Enclosure 3 to Long Mott Energy, LLC, Letter No. 2025-PLM-NRC-013

PSAR Subsection 2.4.4, "Potential Dam Failures"

**Long Mott Generating Station
Preliminary Safety Analysis Report**

SUBSECTION 2.4.4 POTENTIAL DAM FAILURES

Figure 2.4.4-16
Pond Breach Scenario 1 – Flood Velocity at the Long Mott Generating Station Site

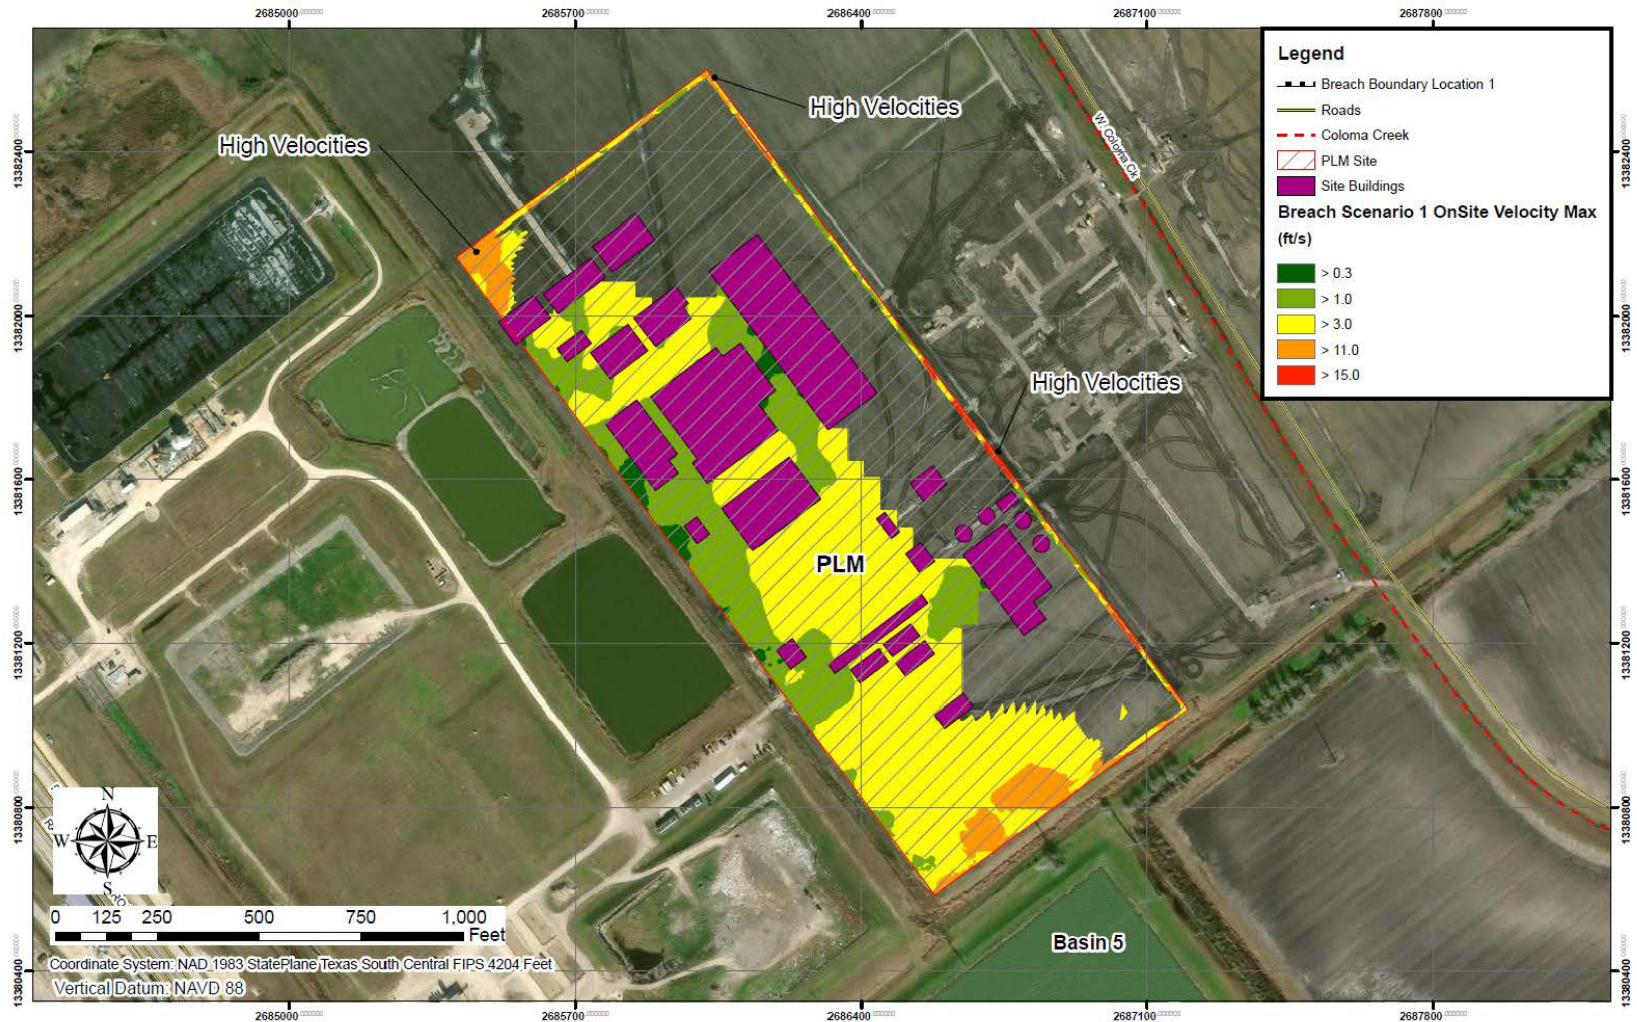
Velocity at the site reaches 6 ft/s (1.8 ~~meters-per-second~~ [m/s]) with the edges of the site experiencing velocity to the range of 10 ft/s (3.1 m/s), which indicates proper sizing of the protection for the site berm should be performed (see Figure 2.4.4-16 and Figure 2.4.4-20).

Figure 2.4.4-14, Figure 2.4.4-16, Figure 2.4.4-18, and Figure 2.4.4-20 show the predicted flood flow velocity pattern at the LMGS site for two on-site scenarios. The maximum flow velocity is estimated to be approximately 11 ft/s (3.35 m/s) in localized areas near the nuclear island, and much lower-3 ft/s (0.9 m/s) per second or less-in the general vicinity. In addition, this flood flow velocity would not be sustained because the flood level would decline in response to the continuous draining of the basins. Under such flow conditions, erosion or scouring is not

Figure 2.4.4-17
Pond Breach Scenario 2 – Overall Inundation Depth

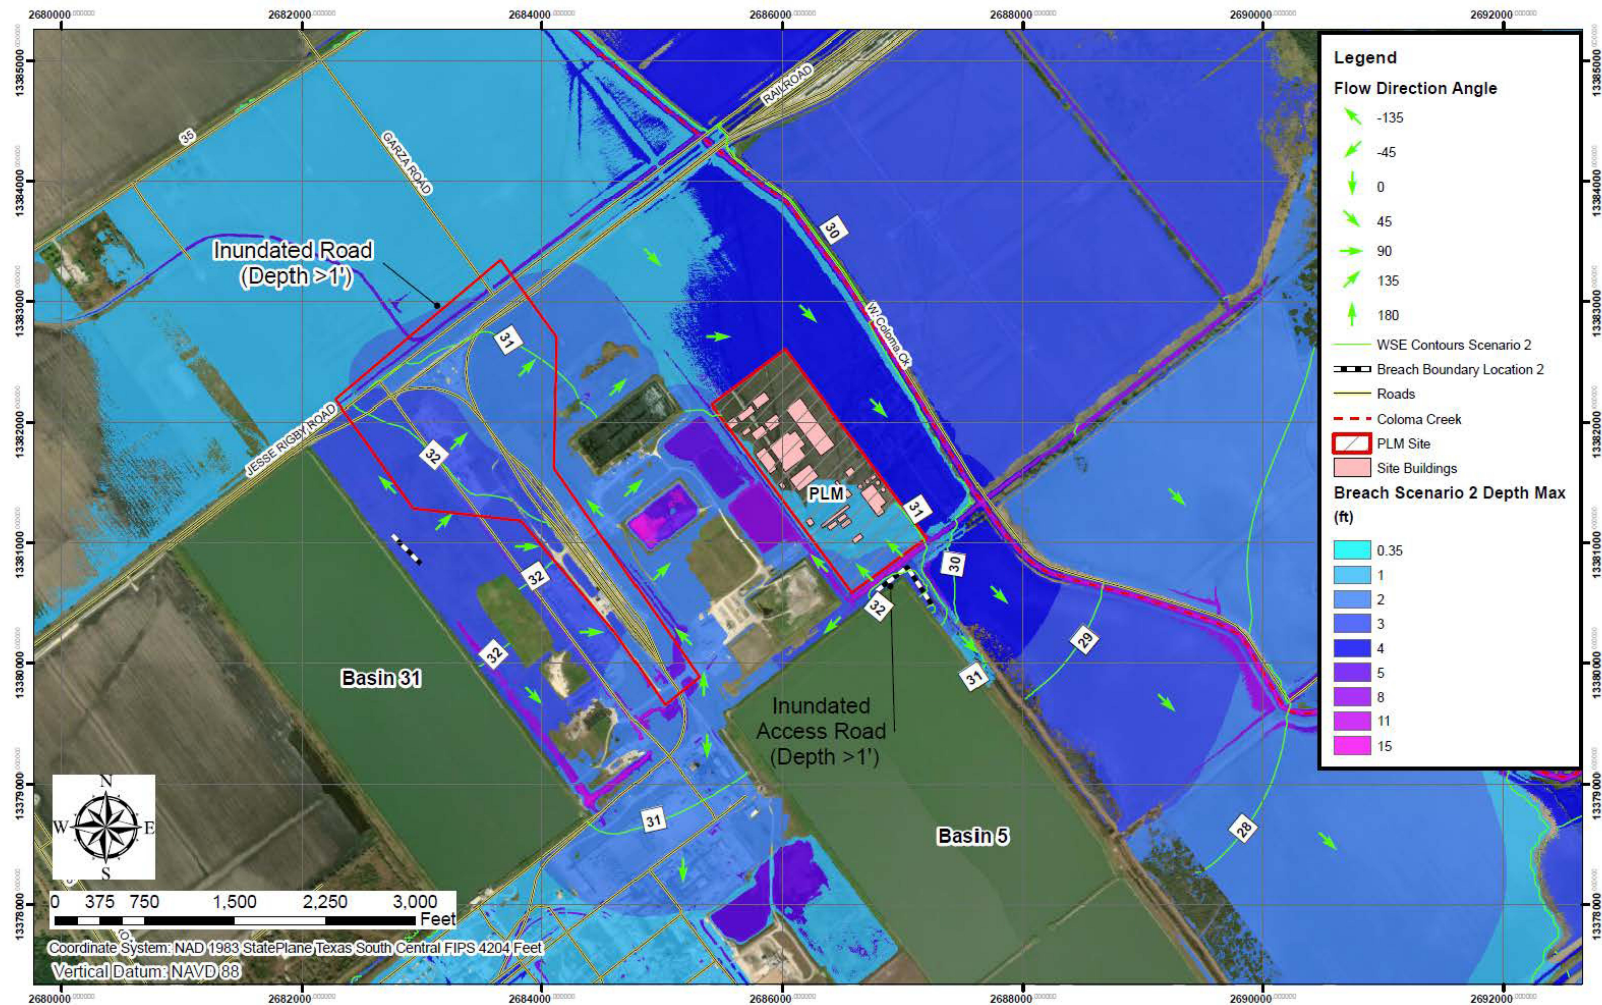
Roads that are inundated by more than 1 ft (0.31 m) are identified for both scenarios (see Figure 2.4.4-13 and Figure 2.4.4-17).

Figure 2.4.4-19
Pond Breach Scenario 2 – Flood Depth at the Long Mott Generating Station Site

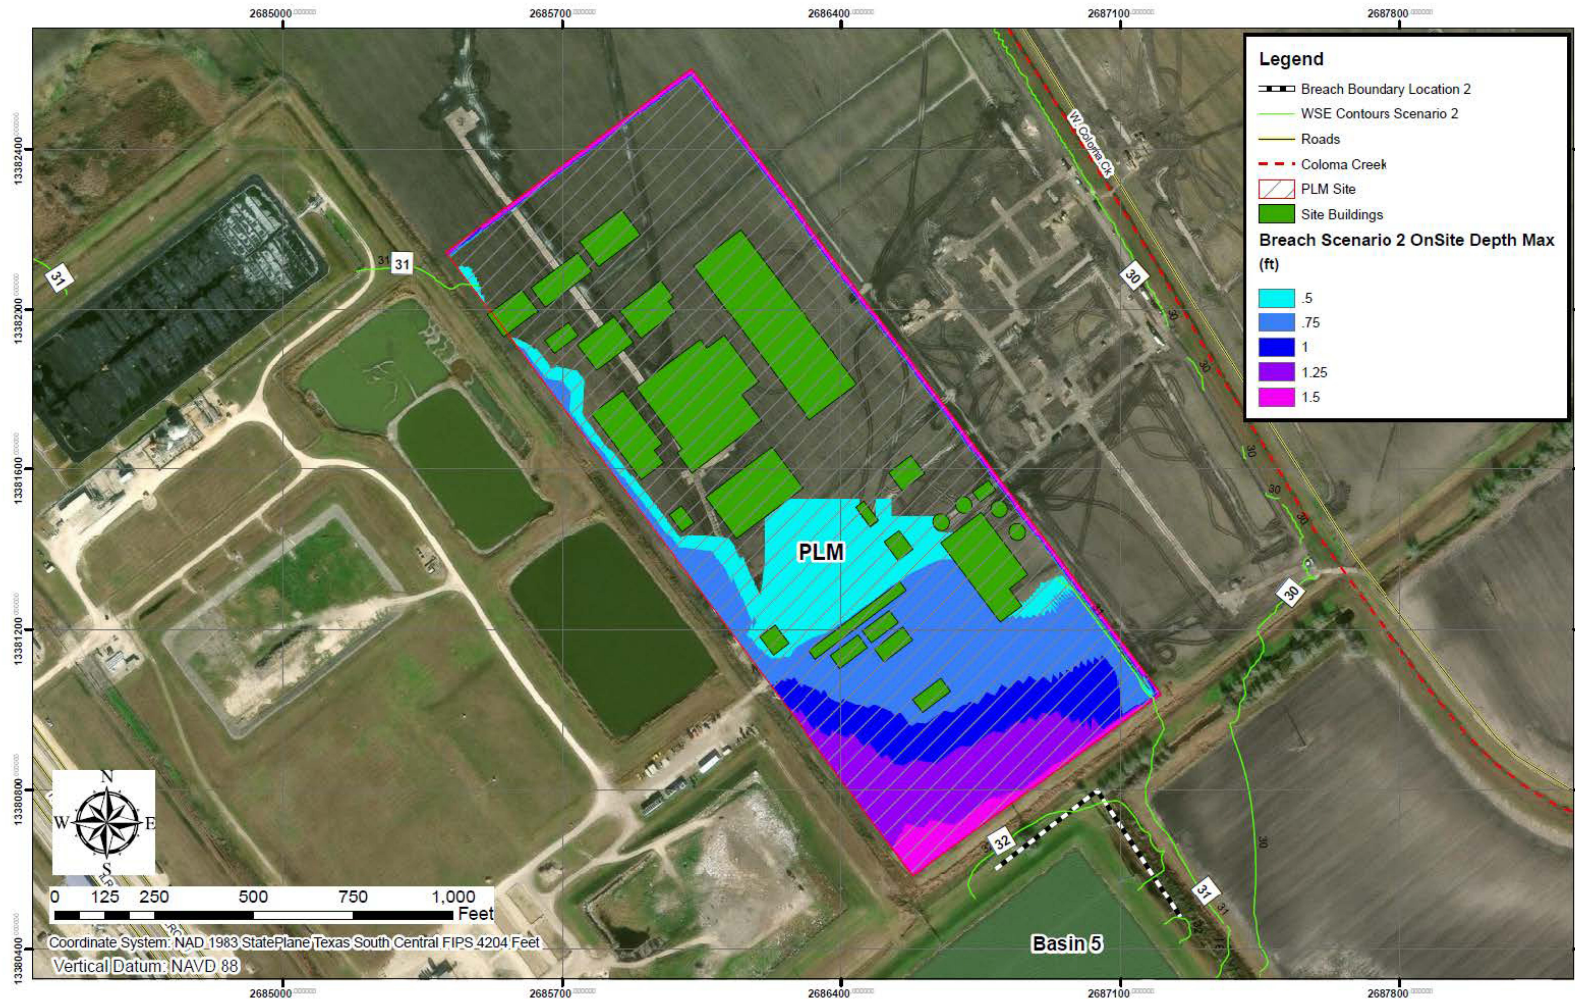
Under Scenario 2, maximum inundation at the LMGS site varies from 6 to 12 in. (15.2 to 30.48 cm) with the western edges of the site experiencing flooding to the range of 1.3 ft (0.4 m) (see Figure 2.4.4-19). However, Scenario 2 is mainly impacting the southern part of the site compared with Scenario 1, which impacts both southern and northern parts of the site.
